Re: Railway (Metrolink - Estuary to Charlemont via Dublin Airport) Order [2022]
Metrolink. Estuary through Swords, Dublin Airport, Ballymun, Glasnevin and City Centre to
Charlemont, Co. Dublin

RE: SUBMISSION ON THE METROLINK ON BEHALF OF JERDIP PROPERTIES UNLIMITED COMPANY IN
RELATION TO PROPERTY AT THE ARTHUR COX BUILDING, 10 EARLSFORT TERRACE, DUBLIN 2,
D02T380

Project Title	Project Metrolink – The Arthur Cox Building	From	Robert Coughlan, PUNCH Consulting Engineers
Project No	222273	To	An Bord Pleanála
Subject	Technical Submission to Railway (Metrolink–Estuary to Charlemont via Dublin Airport) Order 2022 at The Arthur Cox Building, 10 Earlsfort Terrace Dublin 02 T380	Cc	
Date	12-01-2023

**Appendix B - Volume 4, Chapter 20- Fig 20.16, sheet 29
of 30**

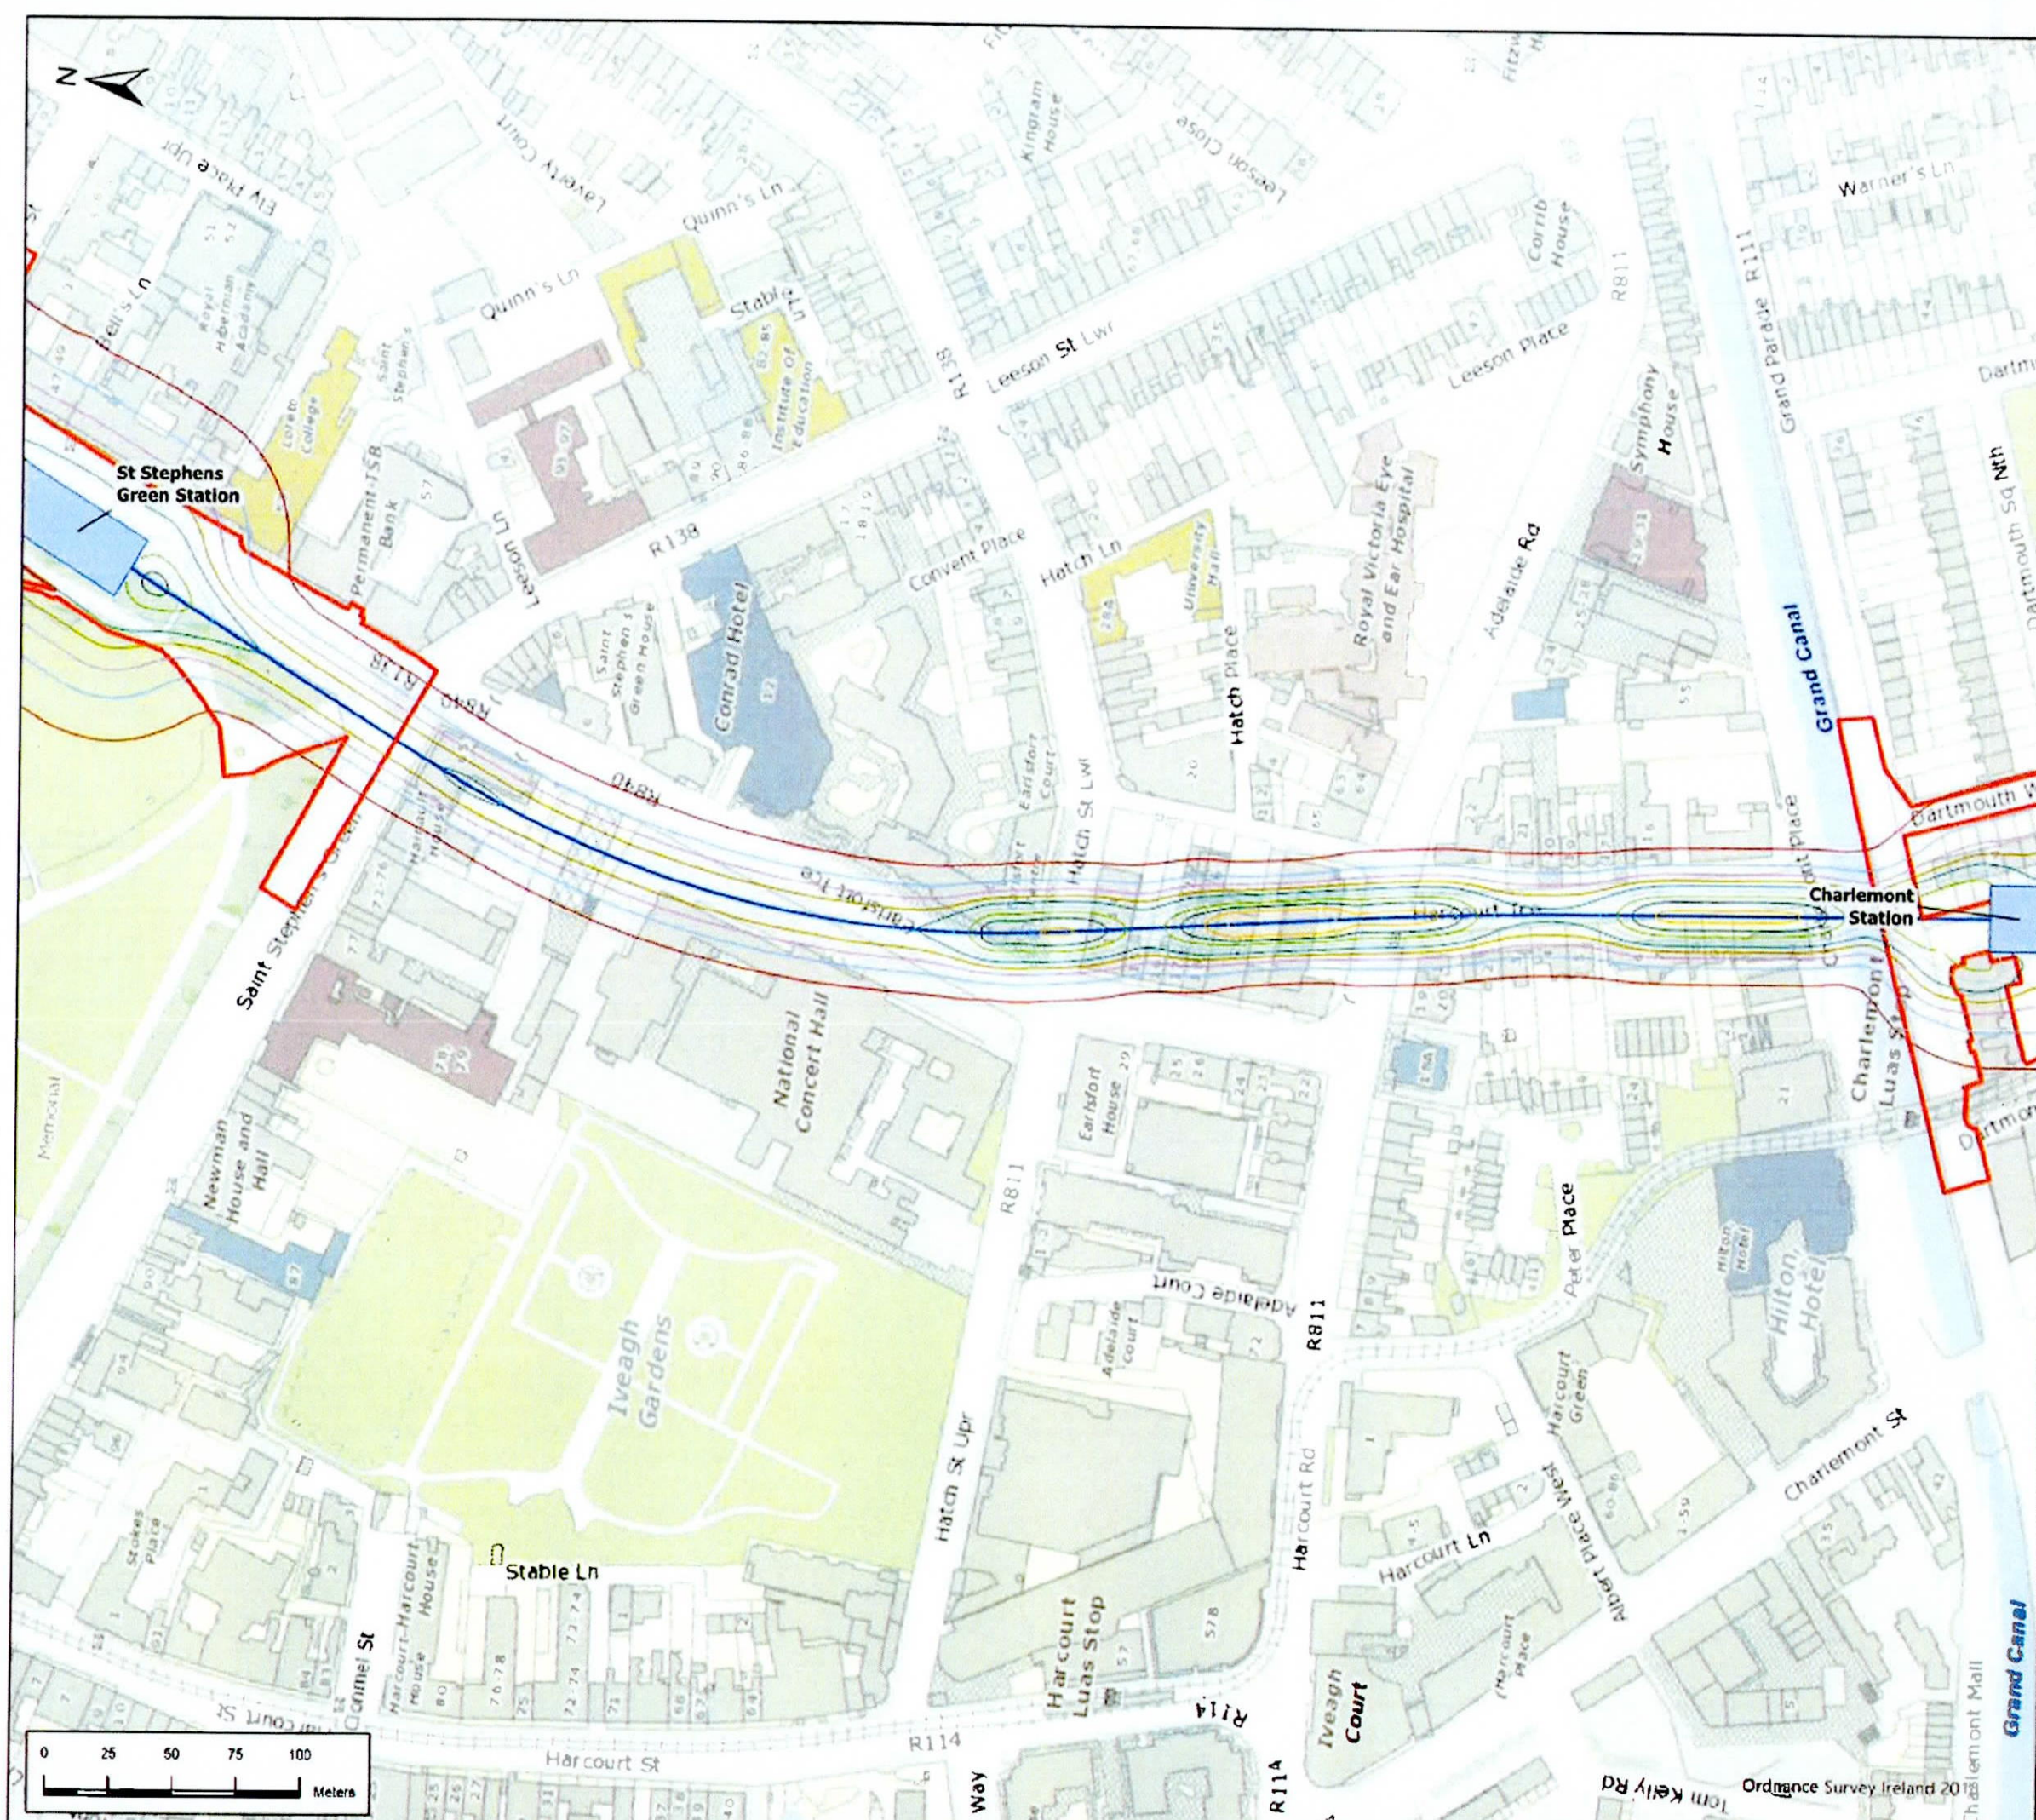
- i) The predicted settlement is a concern from available information on <https://www.metrolinkro.ie/>. The settlement contours on Volume 4, Chapter 20- Fig 20.16, sheet 29 of 30 (Refer to Appendix B), suggest settlement of 40-45mm in the calculated settlement trough. We request details from TII on how they established this deflection data.
